**FINAL DRAINAGE REPORT
FOR
MEISMAN PROPERTY
THAT PART OF S2 LY WLY OF HWY 85 AND SELY OF PLATTED...
21255 CALLE PACIFICO POINT
PUEBLO, COLORADO**

MARCH 2022

TNE Job No. 2071.00
County Job No. PPR2173

SUMMARY

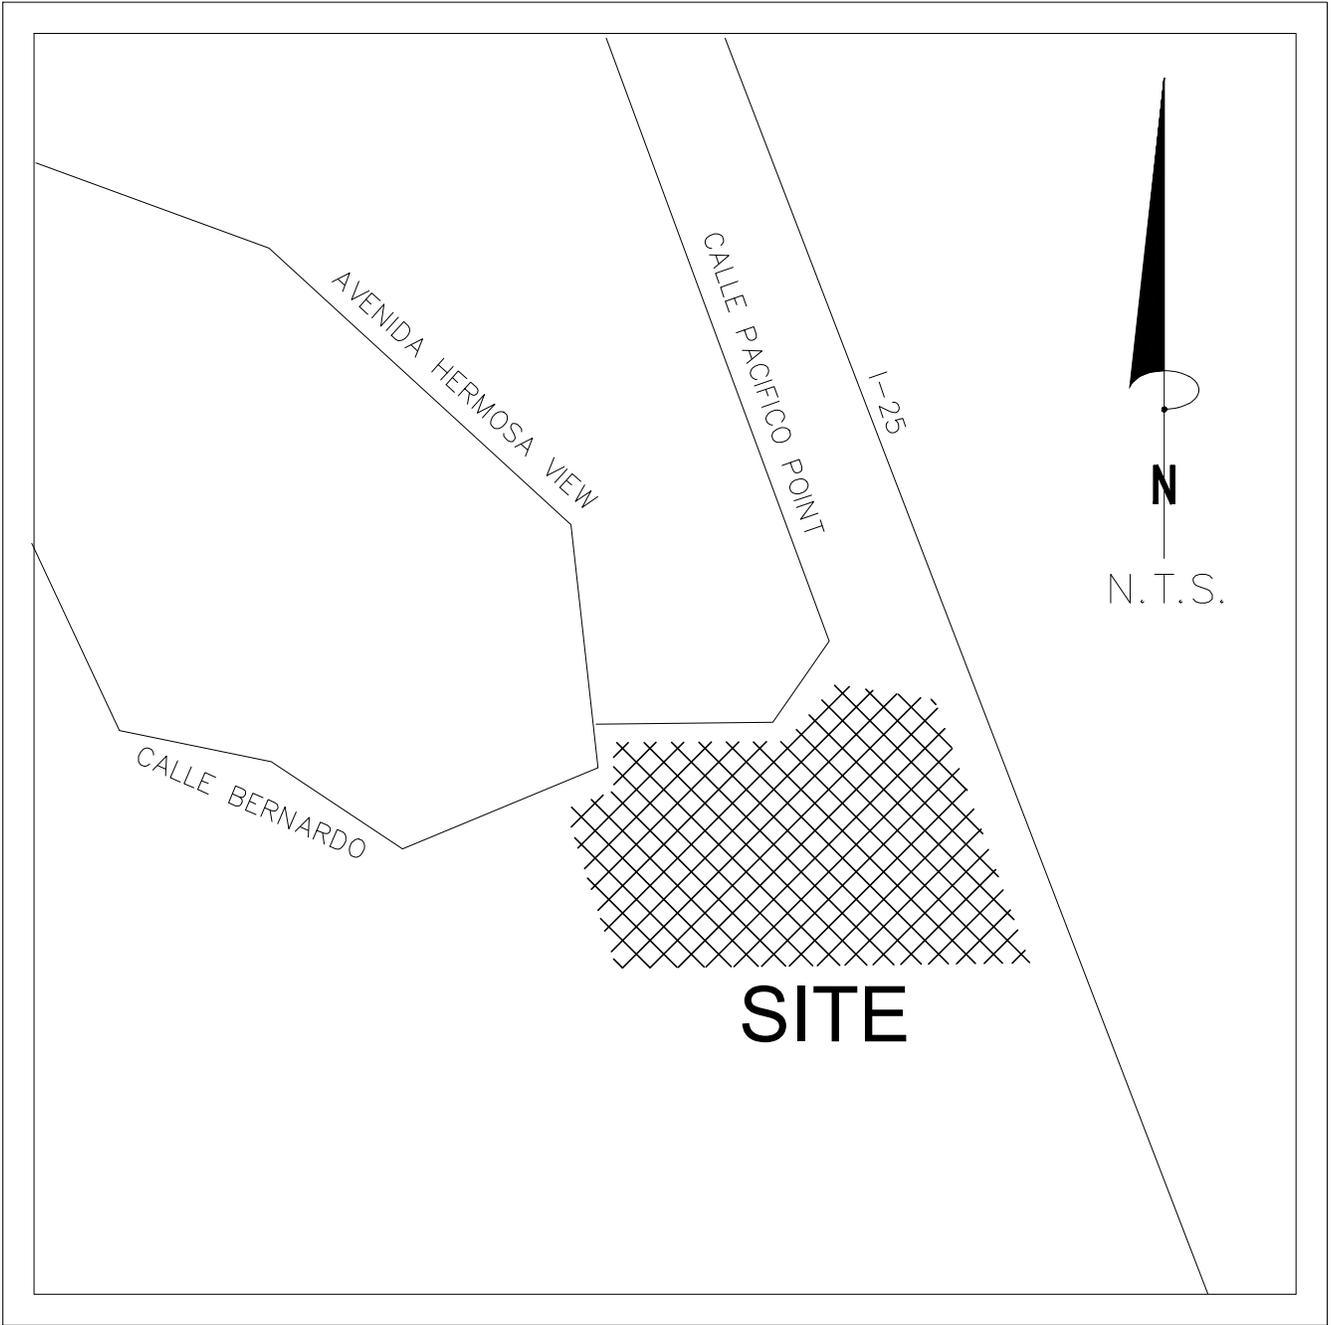
This is the existing conditions summary not the proposed. please revise accordingly.

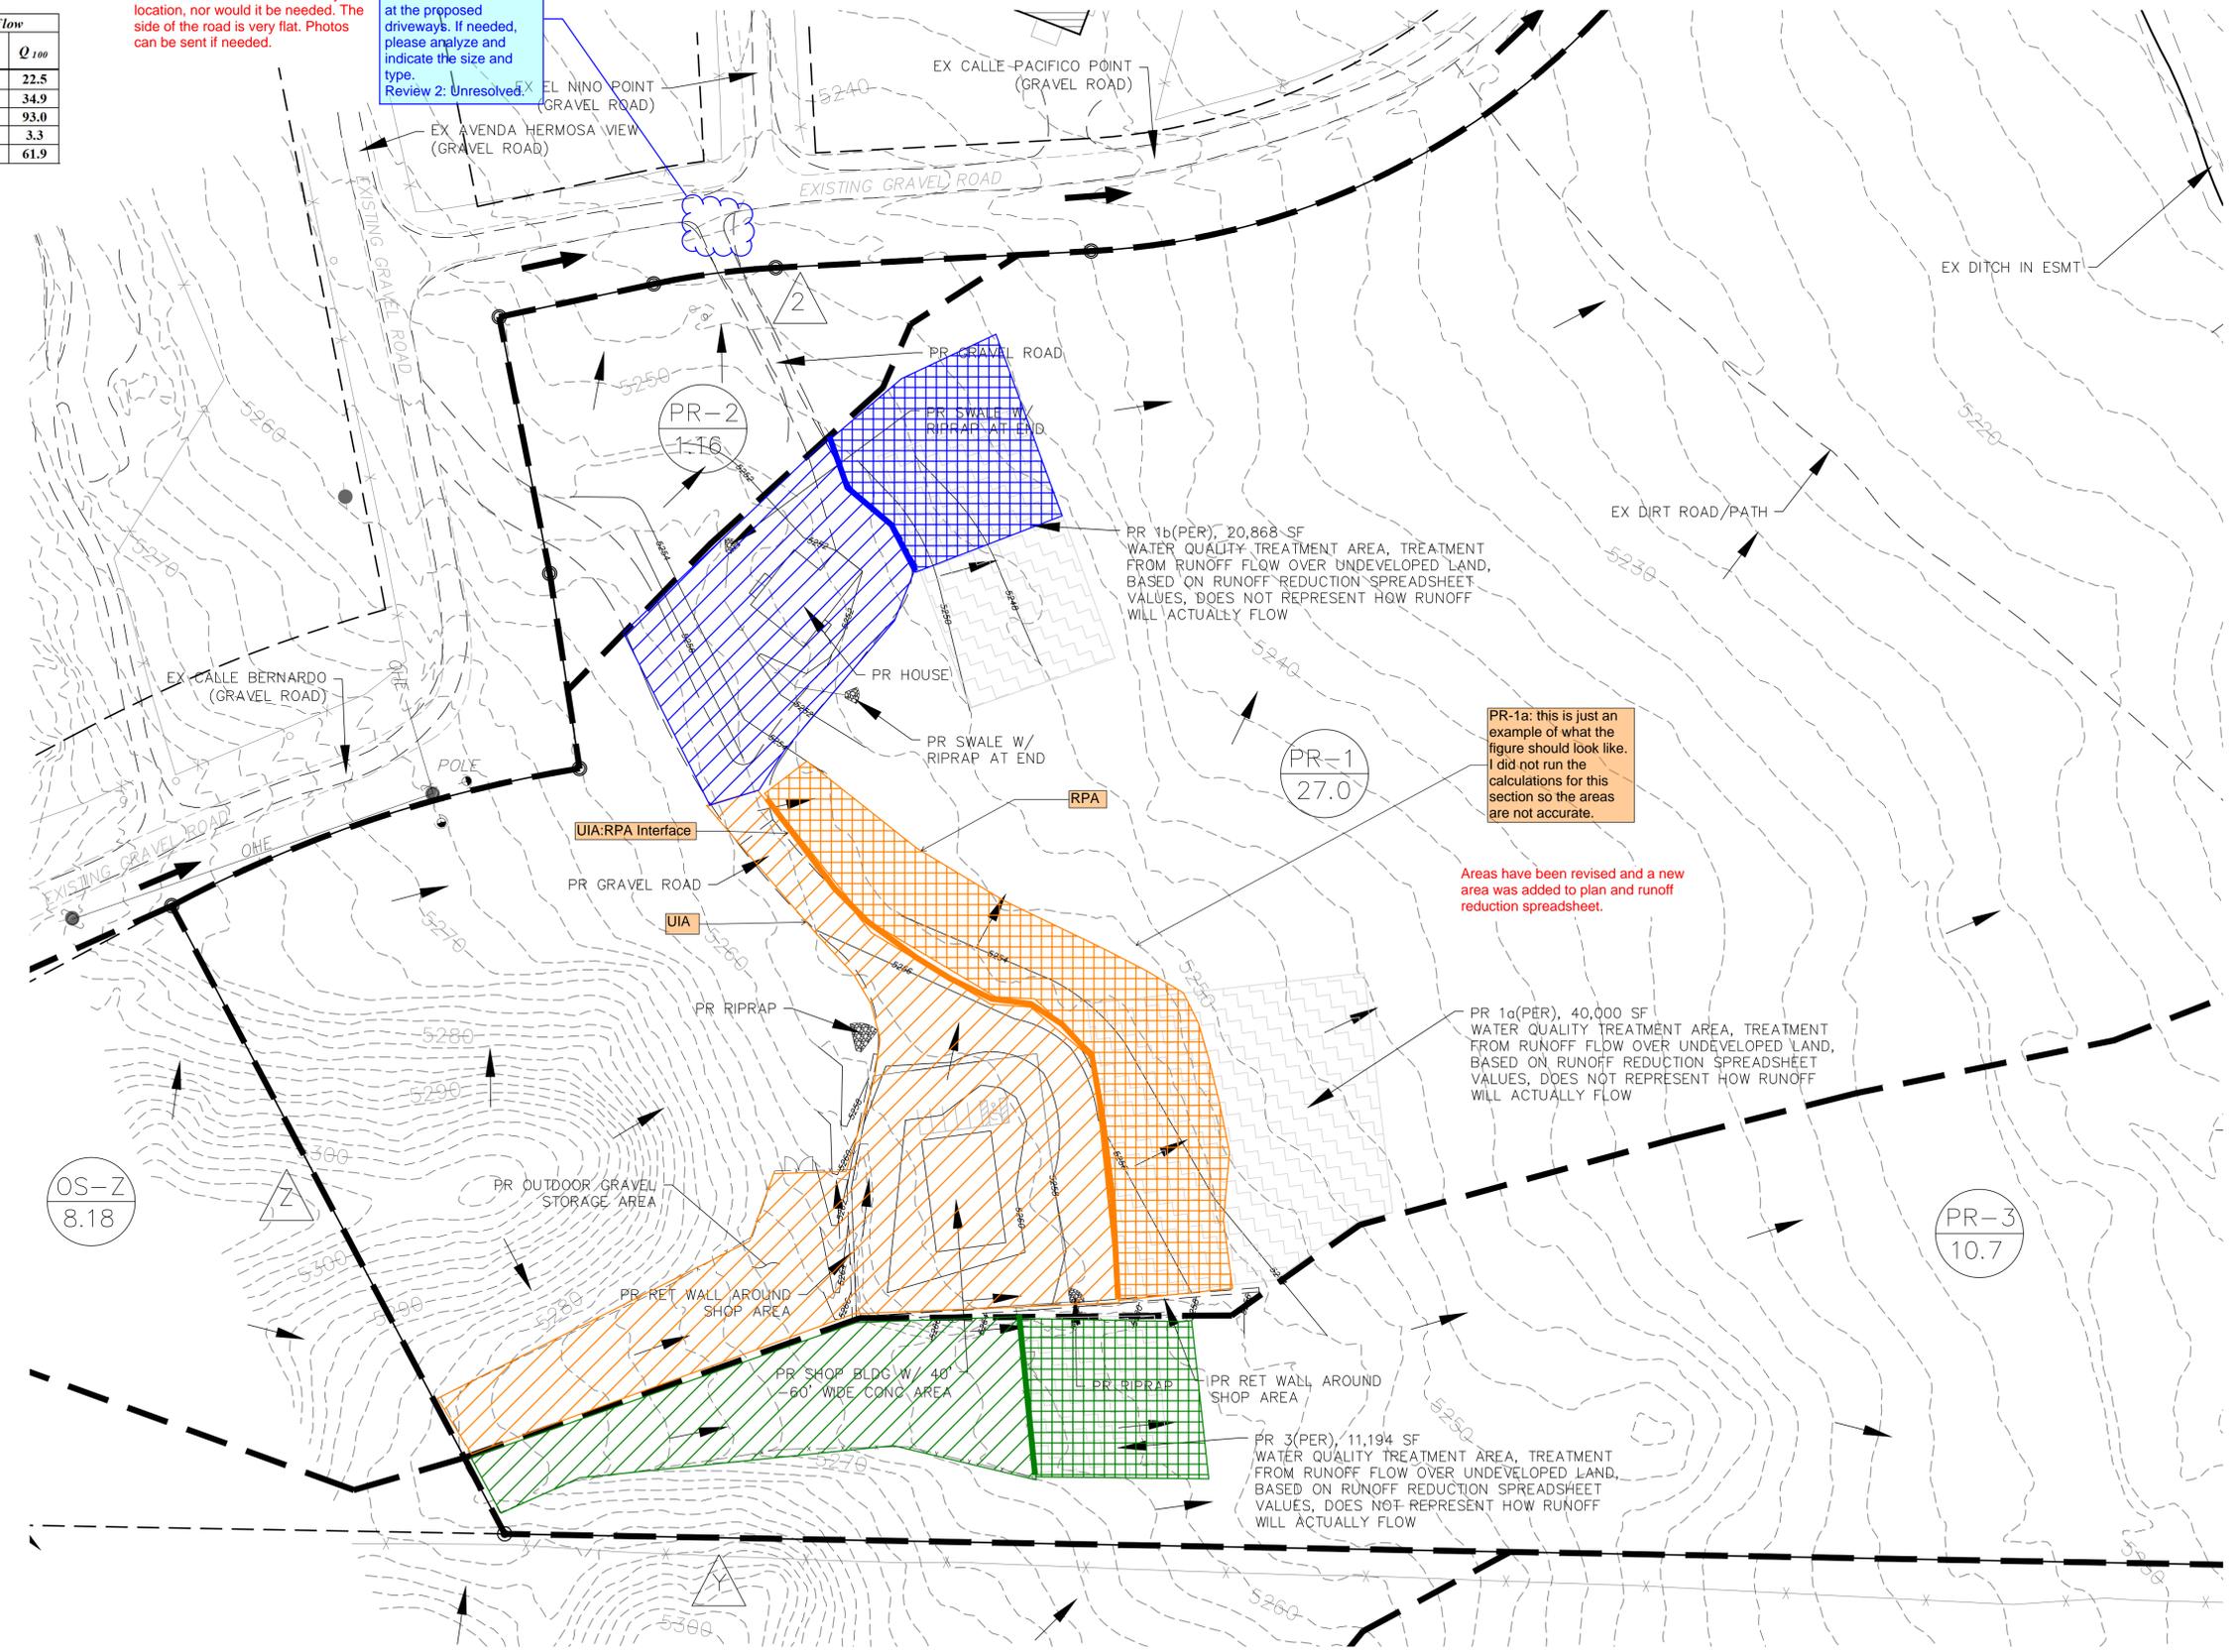
Review 1 comment: Please indicate whether or not a culvert is needed/recommended at the proposed driveways. If needed, please analyze and indicate the size and type.
Review 2: Unresolved

A site visit determined that a culvert would not work in either driveway location, nor would it be needed. The side of the road is very flat. Photos can be sent if needed.

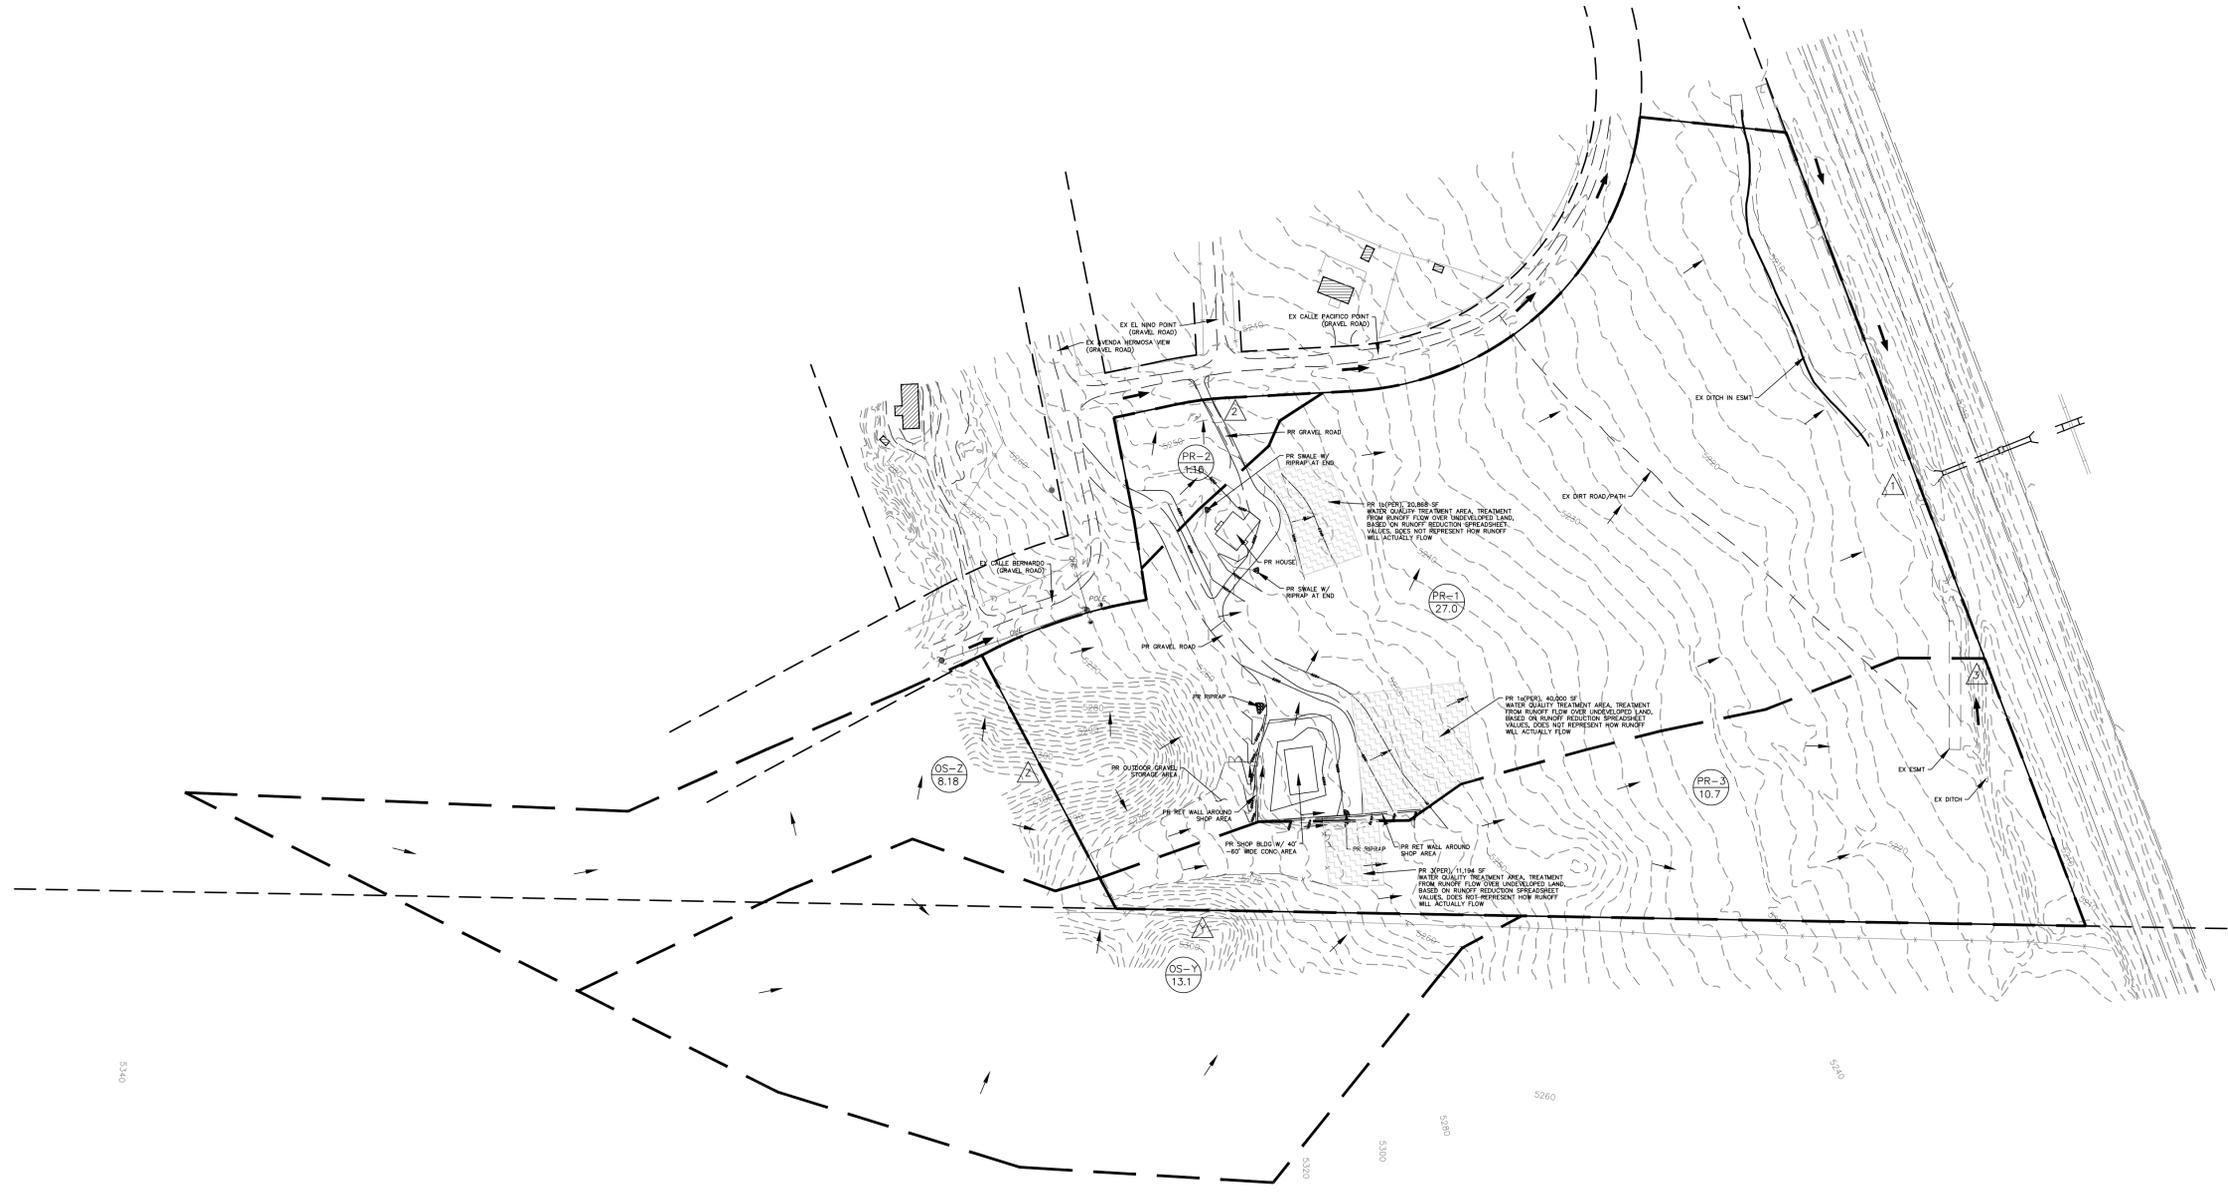
5 year and 100 year flows are inconsistent with flows on page 32. Please revise.
